**DOCKET NO: A-93-02
V-B-15**

**TECHNICAL SUPPORT DOCUMENT FOR
SECTION 194.24: CONSOLIDATED COMPLIANCE REVIEW OF
WASTE CHARACTERIZATION REQUIREMENTS**

**U.S. ENVIRONMENTAL PROTECTION AGENCY
Office of Radiation and Indoor Air
Center for the Waste Isolation Pilot Plant
401 M Street, S.W.
Washington, DC 20460**

MAY 1998

Figure 4-1: Baseline Inventory Report Review - Final Form Volume

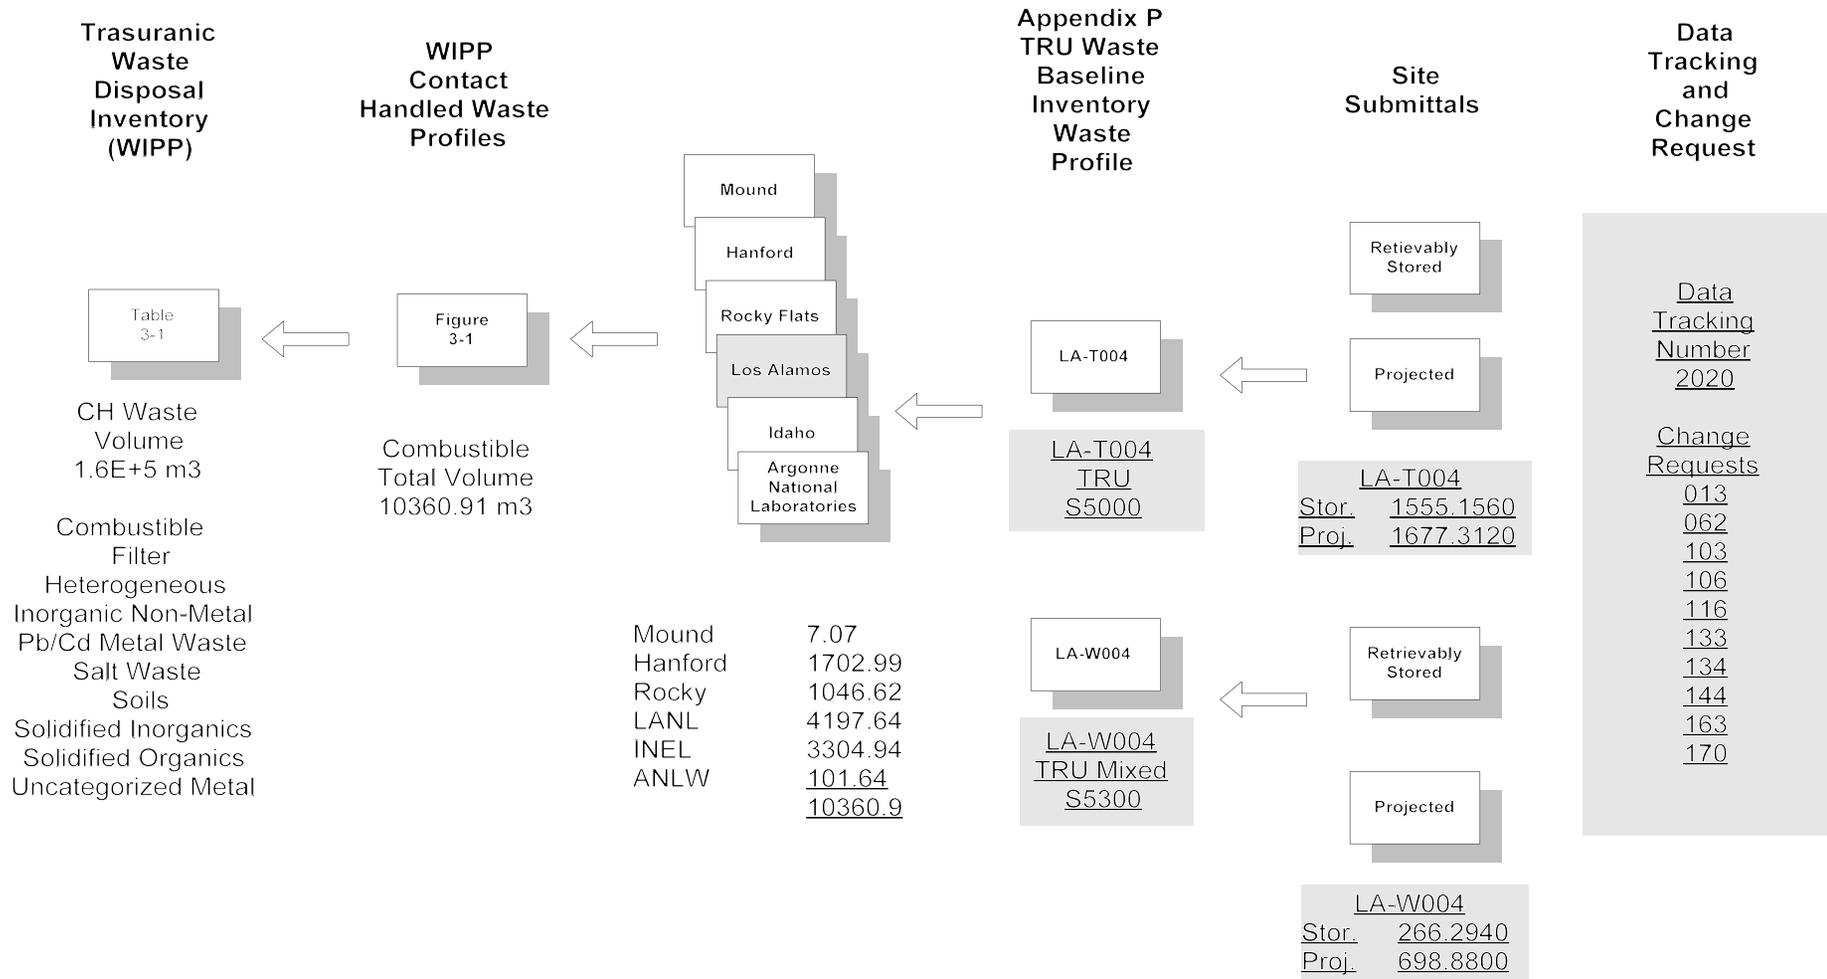
EPA evaluated the traceability of reported values for CH-TRU combustible final waste form volumes back to generator site data submittals (refer to Figure 4-1). A combustible final waste form volume of $1.4 \text{ E}+04 \text{ m}^3$ was reported in Table 2-1 of TWBIR Rev. 3 and also reported in Table 4-3 of the CCA. Six different facilities reported either inventory quantities or projected final waste form volumes for combustibles. Data submitted by Los Alamos National Laboratory (LANL) were then further assessed, and two waste stream profiles (a total of approximately $4,200 \text{ m}^3$ of CH-TRU combustibles) were selected for further examination:

EPA observed that all changes to site submitted data were documented. It was observed, while reviewing data change forms and in discussions with DOE representatives, that the reasons for many of the changes were known by the personnel managing the data base, although the reasons were not clearly documented.¹⁸

Figure 4-2: Baseline Inventory Report Review - Waste Material Parameter

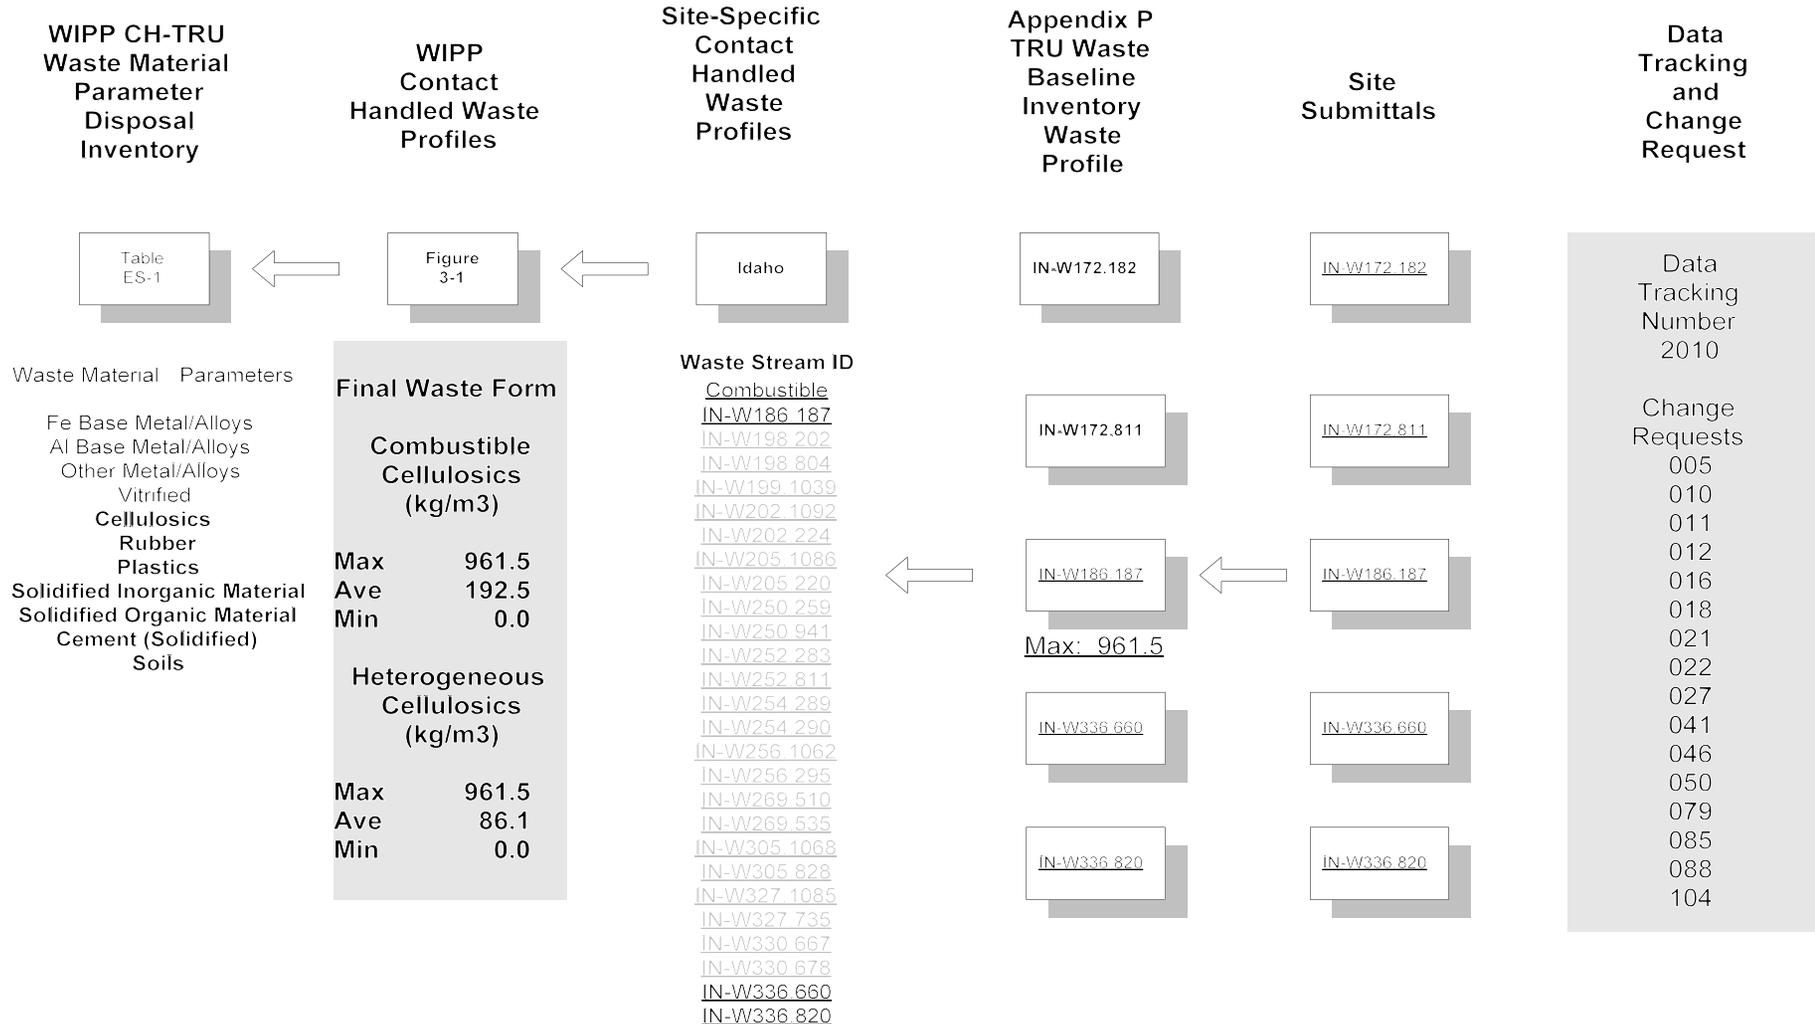
As part of the TWBIR Rev. 3 review, EPA examined the traceability of the maximum reported value for the CH-TRU cellulosic waste material parameter for combustible waste volumes (see Figure 4-2). Table ES-1 of TWBIR Rev. 3 reports a maximum waste material parameter disposal volume for cellulose of $9.6E+02 \text{ Kg/m}^3$. As a first step, EPA reviewed the TWBIR to identify all waste stream profiles that could comprise the cellulosic WMP. EPA reviewed the WIPP CH-TRU Waste Stream Profile forms and identified six facilities that reported inventory volumes for cellulose and final waste form volumes for combustible wastes; 16 facilities reported inventory volumes and final waste form volumes for heterogeneous wastes.

EPA found that all changes to site submitted data were adequately documented. EPA further found that the maximum density of $9.6E+02 \text{ Kg/m}^3$ was traceable from the change reports and the site submittals. EPA observed that for some changes examined, the specific reasons for the change were not presented.

Figure 7-1: Block Diagram of LANL PAN System

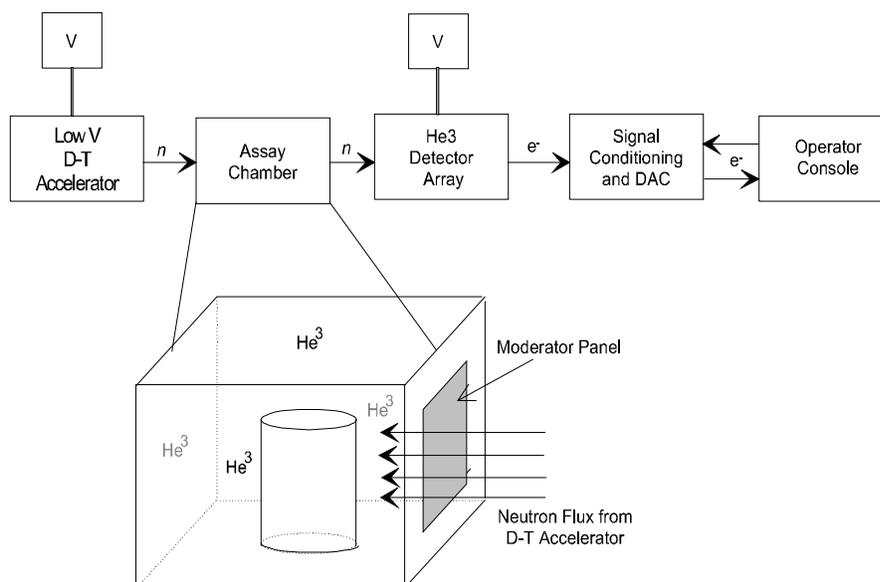
NDA Methods - LANL plans to use the Passive Active Neutron (PAN) system, located in Technical Area 54, to analyze WIPP waste. This system, which is based on the N2/N156 assay systems designed by Caldwell at LANL (SHU 91), assays 55-gallon drums using coincidence counting. The PAN system was developed to operate either as a passive neutron counter or to interrogate the drum with accelerator produced neutrons and count the neutrons generated by the induced fission events. The system is thus capable of active or passive neutron counting to determine the inventory of the drum being assayed. The PAN uses predetermined calibration curves for neutron absorption and moderation within the waste matrix to develop source inventory based upon count rate. Therefore, prior knowledge of the waste matrix allows (and is essential for) the assay system to be "tweaked" with specific calibration information to produce better accuracy. Although they were developed initially at LANL, these systems were used extensively at INEEL where they underwent considerable modifications prior to returning to LANL for use on the WIPP project, particularly with respect to their analysis software, NUC 2, which was installed on the LANL system two years ago. The PAN system currently reports the active assay results if they indicate less than three grams of plutonium; passive results are reported if the active assay plutonium results exceed three grams (DTP 97b). Recent work by LANL indicates a preference for using passive results, as they are less prone to bias (DTP 97b). Figure 7-1 provides a block diagram of the LANL PAN system.
